Access Compliance Report Public Rights-of-Way (Curb Ramps)

Intersection ID: 10121 Main Street: DOLPHIN LN Cross Street: RUTH DR Location: W Initial Pass/Fail: Fail **Overall Compliance: No Severity Score:** ADA ID: F699033C67D2 Ramp Type: Directional1 1.25

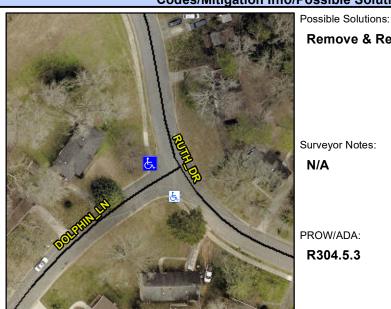
Surveyor Notes: N/A PROW/ADA: R304.5.3

Compliance Description Data Compliance Description Data N/A N/A Ramp Length (in) 91.5 Grade Break? N/A 60.0 N/A Yes Ramp Width (in) Grade Break Slope (%) 0.0 N/A Yes Ramp Slope (%) 5.1 Grade Break XSlope (%) 0.0 No Ramp XSlope (%) 4.0 N/A Flare Type LT N/A N/A Flare Type RT N/A N/A Flare Slope LT (%) N/A N/A Flare Slope RT (%) 0.0 N/A Flare Traversable LT? N/A N/A Flare Traversable RT? N/A N/A 0.0 N/A DWS Provided? Landing Length (in) N/A N/A Landing Width (in) 0.0 N/A **DWS Contrast?** N/A N/A Landing Slope (%) 0.0 N/A DWS Length (in) N/A N/A N/A DWS Full Width? Landing X Slope (%) 0.0 N/A N/A Landing Curb? (Y/N) N/A N/A DWS Offset LT (in) N/A N/A Shared Landing? N/A N/A DWS Offset RT (in) N/A N/A **Gutter Ponding?** 0.0 N/A Gutter Slope (%) N/A N/A Gutter Lip Ht (in) 1.0 N/A Gutter X Slope (%) N/A N/A Painted X Walk1? No Road Slope (%) 4.2 To SE X Walk 1 Direction Road X Slope (%) 0.9 X Walk 1 Width (in) N/A Clear Space? N/A 4.2 N/A N/A X Walk 1 Slope (%) Clear Space to XWalk (in) X Walk 1 X Slope (%) 0.9 N/A Storm Grate/Utility Hazard? N/A N/A Ramp inside XWalk1? N/A Storm Grate/Utility Type N/A N/A Any Obstructions? N/A **Obstruction Type** Surface Condition? (G/P) Yes Good N/A N/A 20.6 Curb Slope (%)

Remove & Replace Entire Ramp.
